09-IEP-1F

RE: *Energy Efficiency in California's Public Power Sector*

**Comments of the Natural Resources Defense Council (NRDC) on the
2009 Integrated Energy Policy Report (IEPR)
Assembly Bill 2021 Implementation**

Docket Number 09-IEP-1F
2009 IEPR – AB 2021
June 30, 2009

Figure 3: Total POU Energy Efficiency Reported Savings and Targets

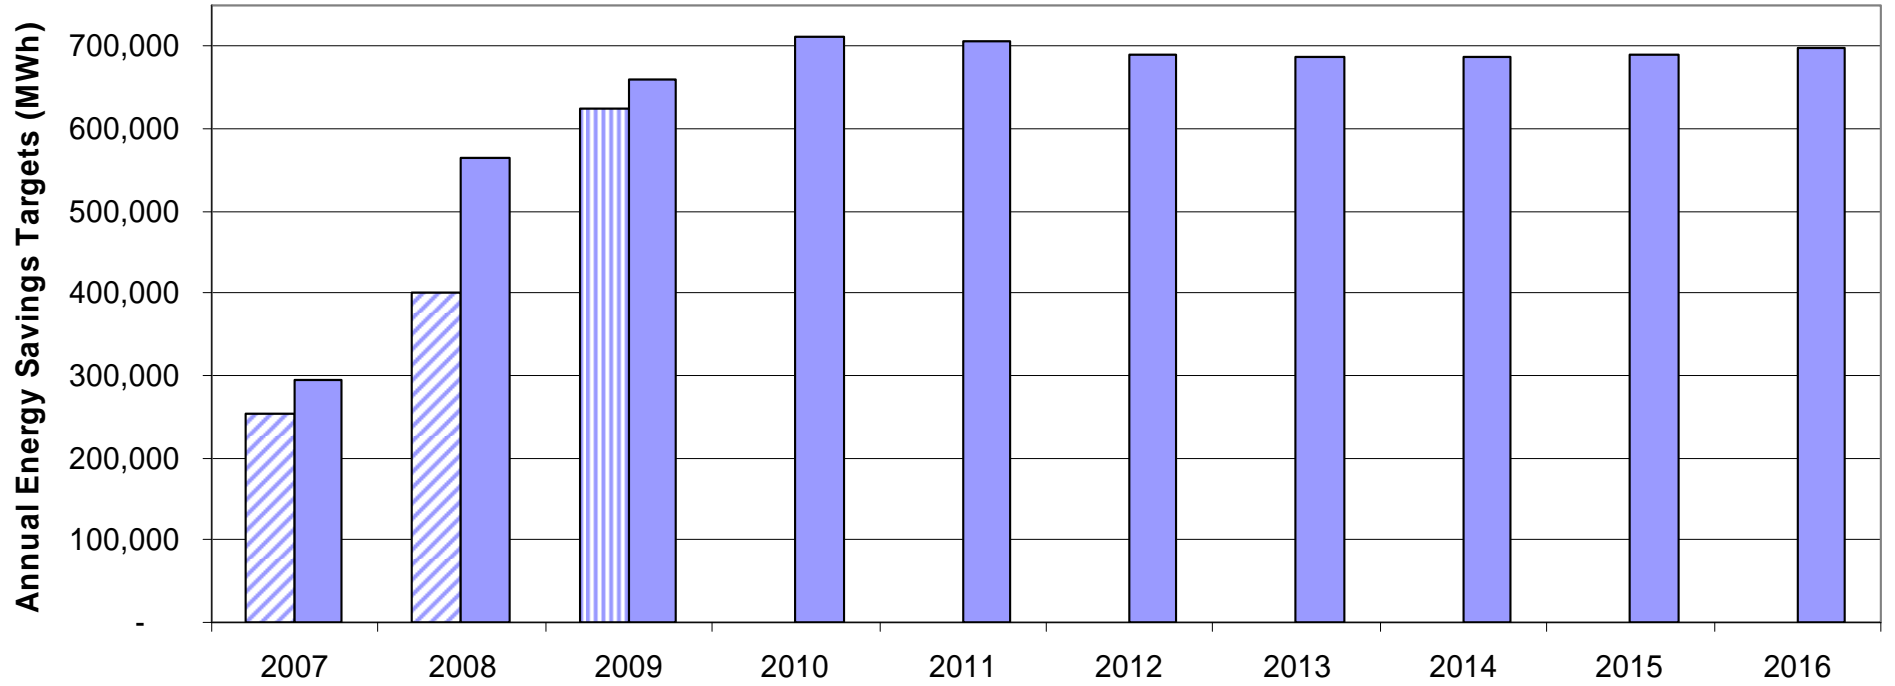
The POU's must exceed their 2009 energy savings projections to ensure that they are able to meet their ten-year energy saving targets pursuant to AB 2021 (see Figure 3 in Attachment A). We are concerned that a number of utilities were unable to achieve their 2008 targets and that, on average, the POU's 2008 reported savings fell approximately 30% short of their AB 2021 targets for 2008.¹⁰ In addition, on average, the POU's 2009 projected savings will fall short of their AB 2021 targets. We would like to learn more about the reasons that a number of utilities have been unable to meet their AB 2021
